To: A. Sutherland Brown

Date: September 8, 1980

Re: Geological Evaluation of Valley Copper
Mining Plan

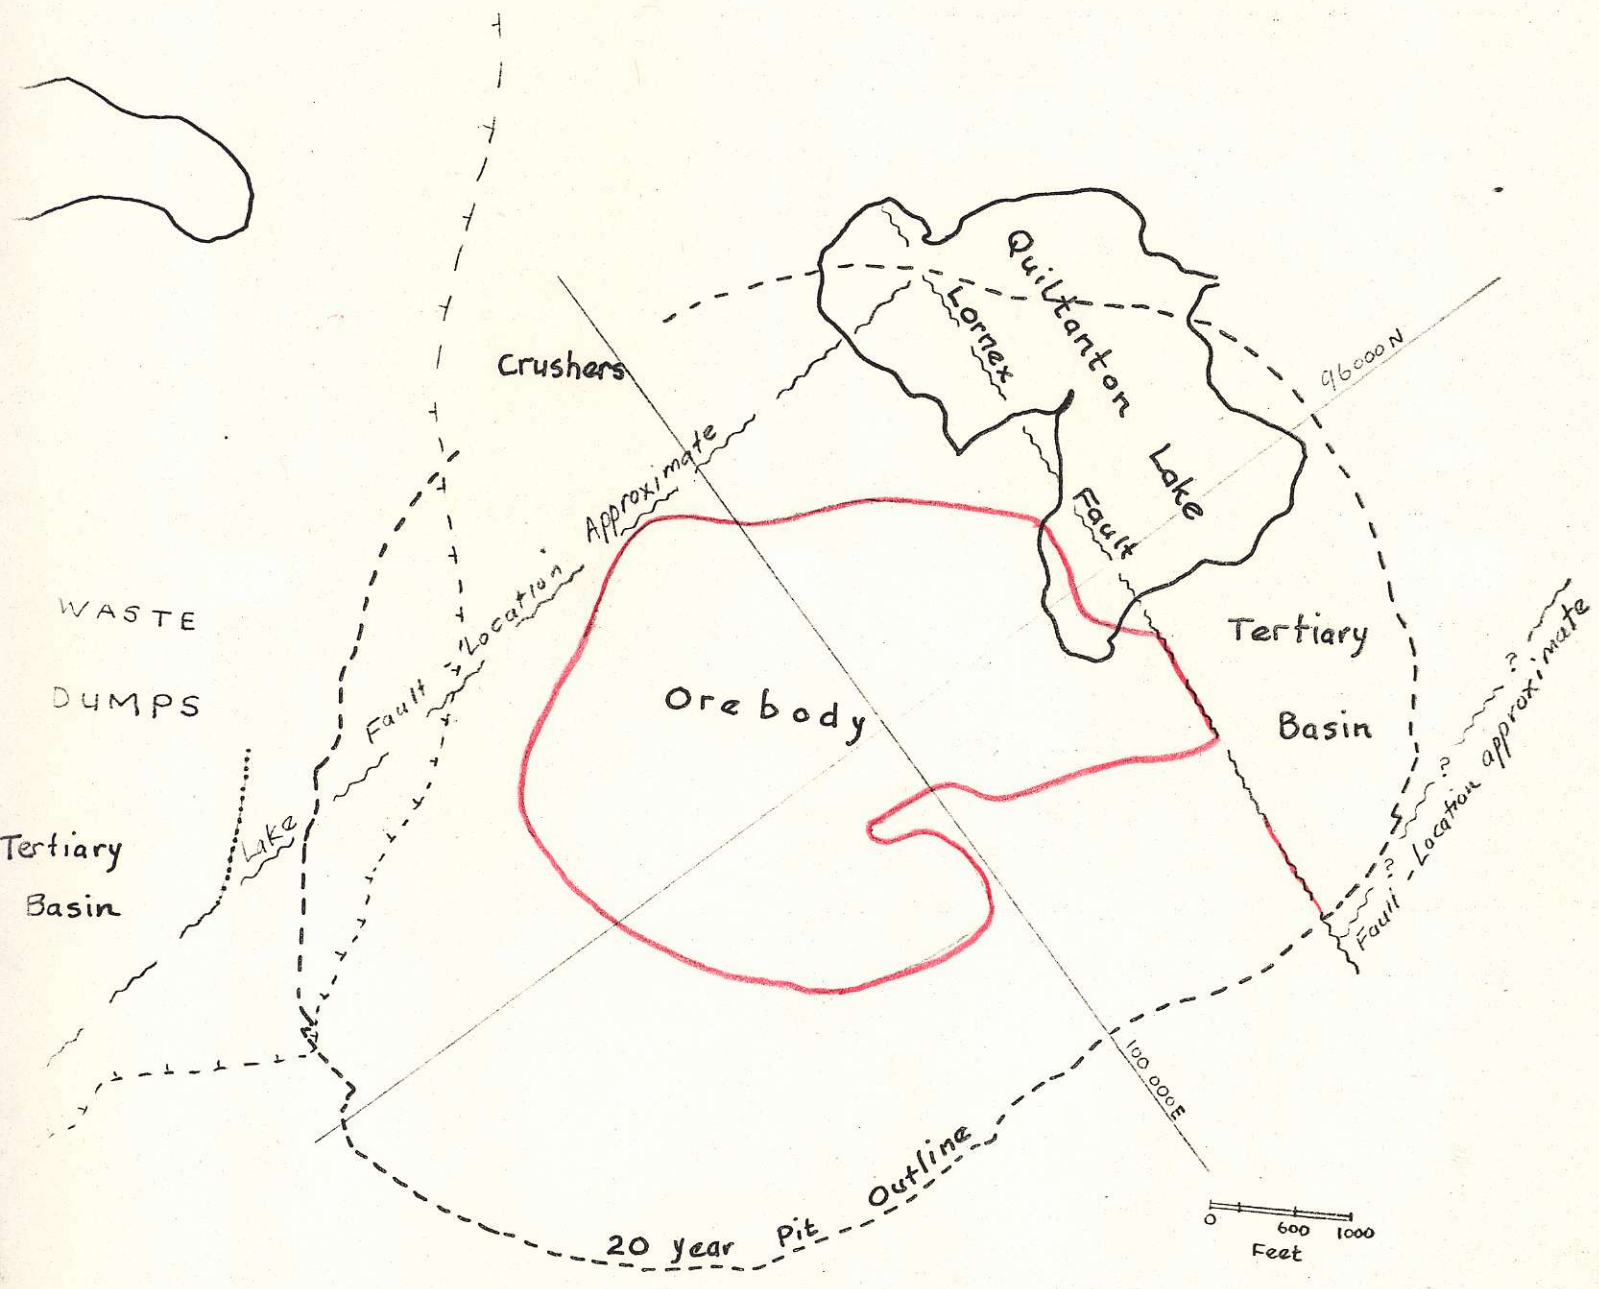
- d) Planned bench slopes appear to have been well researched but there may be some problems with the southeast corner of the 20 year pit south of Quiltanton Lake. In that area, Tertiary sedimentary rocks underly the glacial overburden. I suspect the Tertiary rocks will behave like overburden and will require similar pit slopes. (Figures 1, 1a, 1b).

VALLEY COPPER DRILL HOLE PATTERN (AS OF 1971)

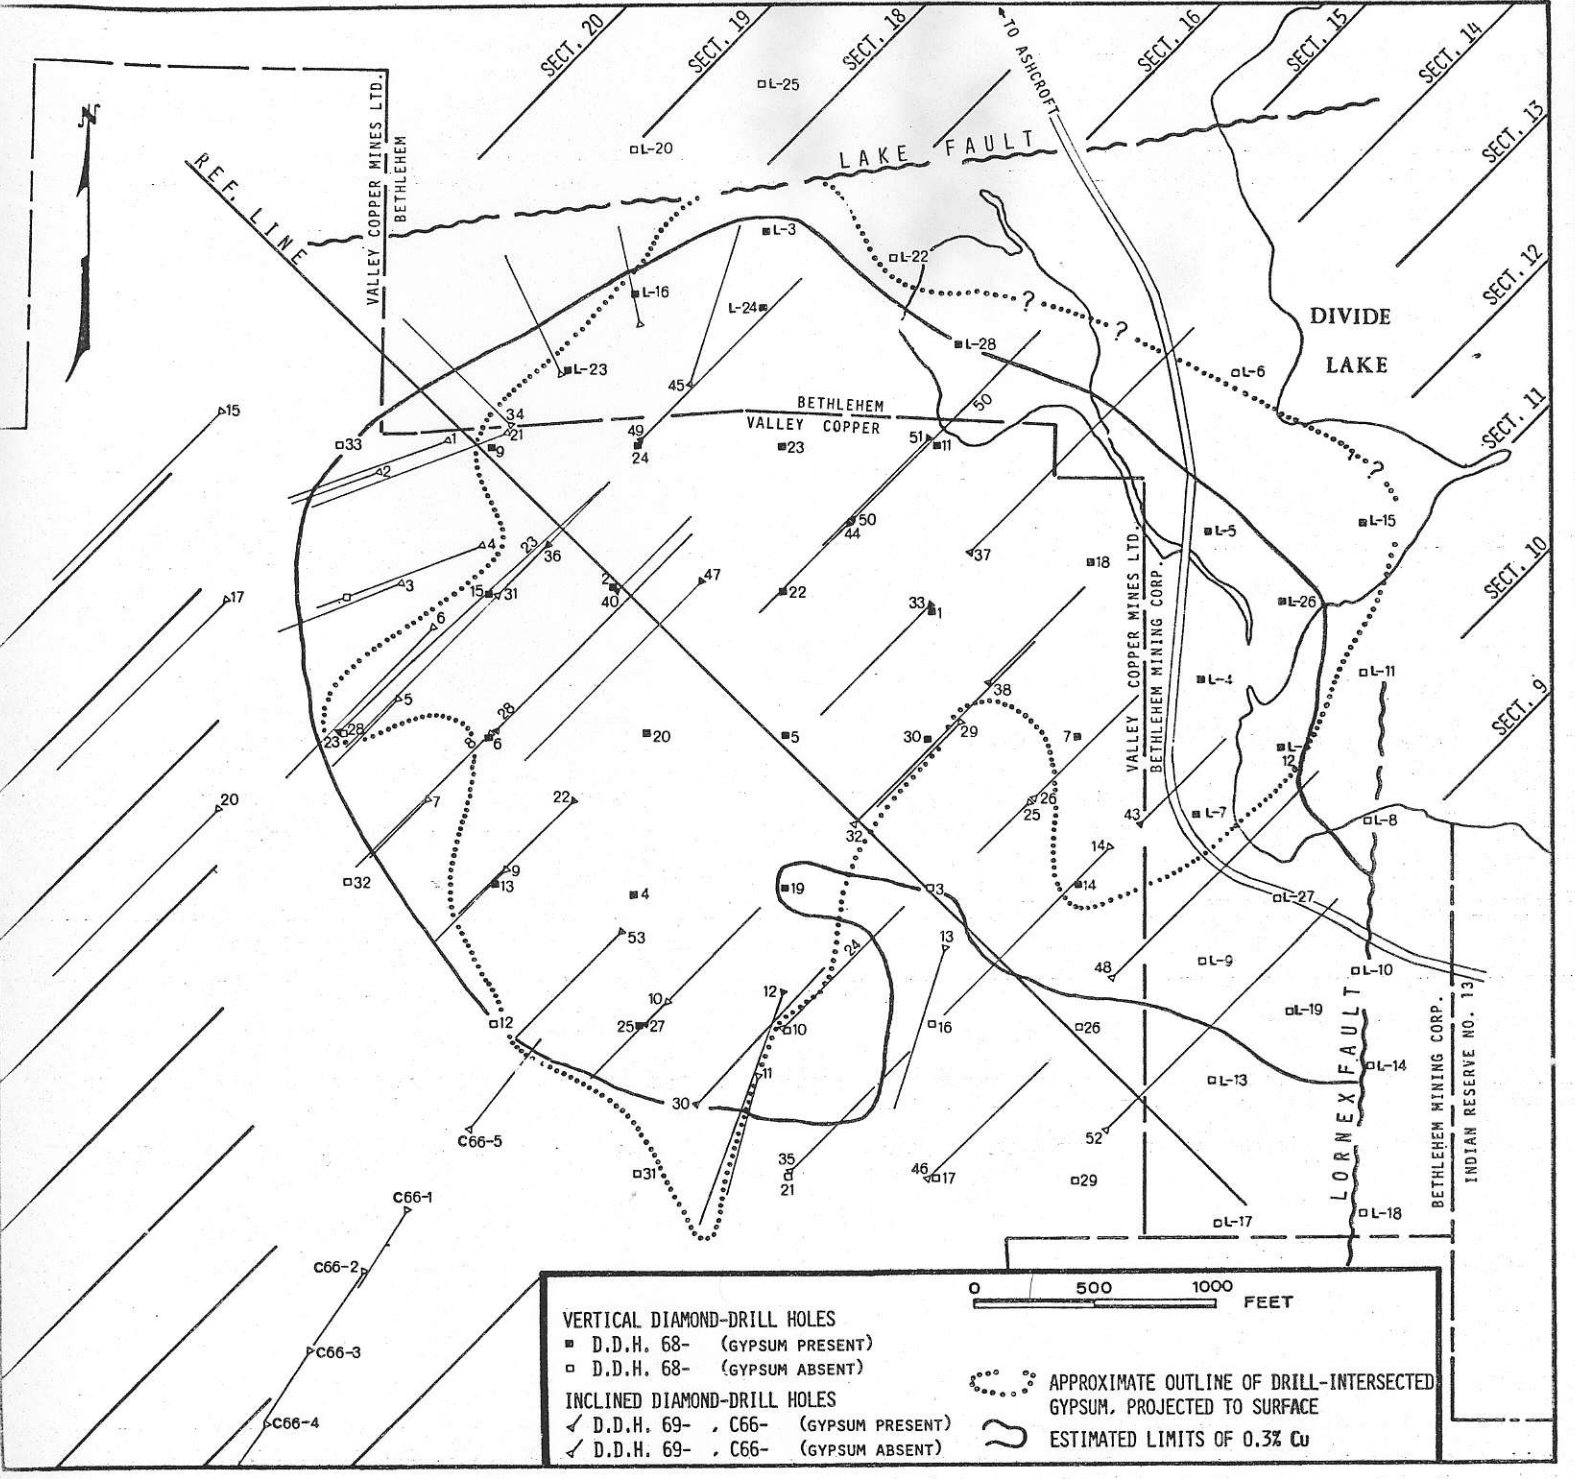
Waste dumps have been positioned so that they will cover areas that have been drilled (Figure 2) and found to have either low mineral potential or very deep overburden. For example, Tertiary sedimentary and volcanic rocks in a basin south of 24 Mile Lake (Figure 3) have no known associated mineralization either in outcroppings or in drill core.
